Access Compliance Report

Public Rights-of-Way

(Pedestrian Signals)

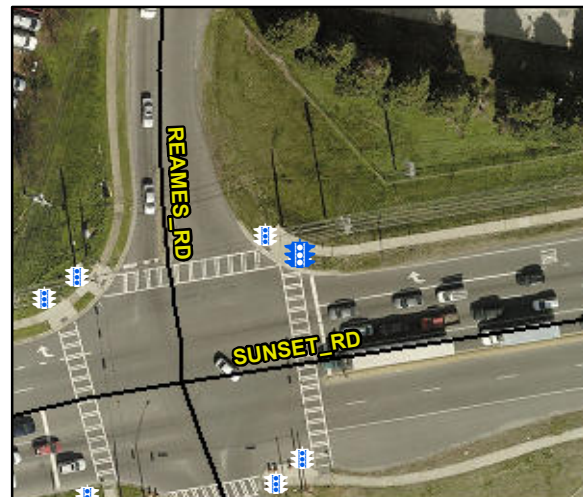
Intersection ID: N/A	Main Street:	Cross Street: N/A	Location: N/A
ADA ID: 83E282A8C7F6	Signal Type: One Push Button-APS	Overall Compliance: No	Severity Score: BTN 1: N/A BTN 2: N/A No BTN: N/A
Codes/Mitigation Info/Possible Solution		Field Measurements/Component Compliance

PROW/ADA: R404.2, R404.3, R404.7.3,
R404.7.2, R209.1, MUTCD 4e.10

N/A	B 1 FWD Approach Width (in)	N/A	N/A	B 2 FWD Approach Width (in)	N/A
N/A	B 1 FWD Approach Obstruction?	Yes	N/A	B 2 FWD Approach Obstruction?	N/A
N/A	B 1 FWD Approach Obstruction Dist (in)	3.0	N/A	B 2 FWD Approach ObstructionDist (in)	N/A
N/A	B 1 PARA Approach?	Yes	N/A	B 2 PARA Approach?	N/A
N/A	B 1 PARA Approach Constrained?	Yes	N/A	B 2 PARA Approach Constrained?	N/A
No	B 1 PARA Approach Reach (in)	24.0	N/A	B 2 PARA Approach Reach (in)	N/A
No	B 1 PARA Approach Width (in)	48.0	N/A	B 2 PARA Approach Width (in)	N/A
N/A	B 1 PARA Approach Obstruction?	Yes	N/A	B 2 PARA Approach Obstruction?	N/A
N/A	B 1 PARA Approach Obstruction Dist (in)	3.0	N/A	B 2 PARA Approach ObstructionDist (in)	N/A
No	B 1 Clear Floor Space Slope (%)	5.9	N/A	B 2 Clear Floor Space Slope (%)	N/A
No	B 1 Clear Floor Space XSlope (%)	3.6	N/A	B 2 Clear Floor Space XSlope (%)	N/A
N/A	B 1 PAR Slope (%)	N/A	N/A	B 2 PAR Slope (%)	N/A
Yes	B 1 Height (in)	34.0	N/A	B 2 Height (in)	N/A

Possible Solutions: Remove & Replace
Replace APS Button With New APS Button.
Remove and Replace Clear Space.
